Project	IEEE 802.16 Broadband Wireless Access Working Group < <a href="http://ieee802.org/16">http://ieee802.org/16</a> >	
Title	Service Primitive for Paging Group Action	
Date Submitted	2005-07-12	
Source(s)	Jee Hyeon Na, Yun Won Chung, PhD Sang Ho Lee, PhD ETRI, 161, Gajeong-dong, Yuseong-gu, Daejeon, 305-700, Korea	<a href="mailto:jhna@etri.re.kr">jhna@etri.re.kr</a> <a href="mailto:yun.chung@etri.re.kr">yun.chung@etri.re.kr</a> <a href="mailto:leesh@etri.re.kr">leesh@etri.re.kr</a> Voice: +82-42-860-5408 Fax: +82-42-861-1966
Re:	Call for Comment on P802.16g Baseline Document	
Abstract	This contribution proposes service primitive for paging group action	
Purpose	The document should be considered during the resolution of comments on the baseline document.	
Notice	This document has been prepared to assist IEEE 802.16. It is offered as a basis for discussion and is not binding on the contributing individual(s) or organization(s). The material in this document is subject to change in form and content after further study. The contributor(s) reserve(s) the right to add, amend or withdraw material contained herein.

# Service Primitive for Paging Group Action

Fig. 2 - Paging Group Action Procedures

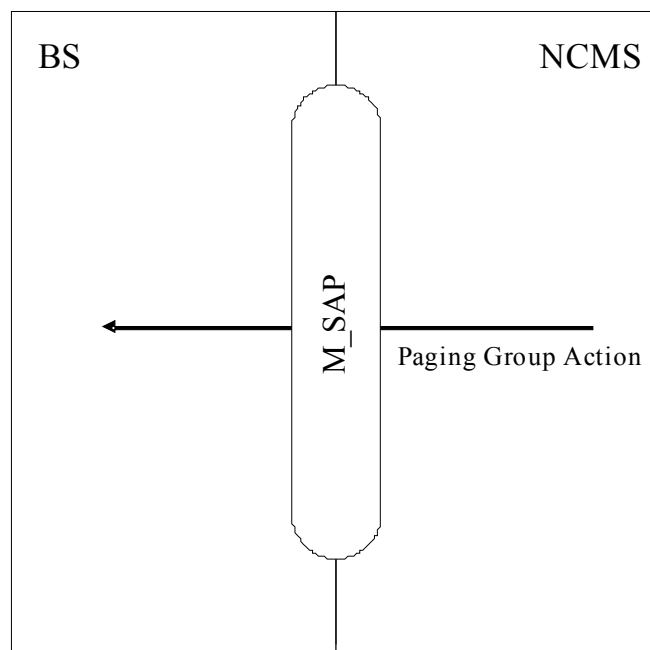
[Modify section 14.5.9.2 as follow]

The location information of an idle MSS is managed by the unit of Paging Group in Paging Service of an NCMS, and paging messages are sent to all the BSs within the called MSS's Paging Group. The NCMS should divide the whole service area into multiple Paging Groups and notify this Paging Group information to all the BSs within the service area, where a BS may be a member of one or more Paging Groups. In this contribution, we propose service primitive for Paging Group Action which are exchanged through Management Service Access Point (M-SAP) of Management Plane specified in IEEE 802.16g baseline document. Paging Group Action is performed by Paging Service of an NCMS, as shown in Fig. 2
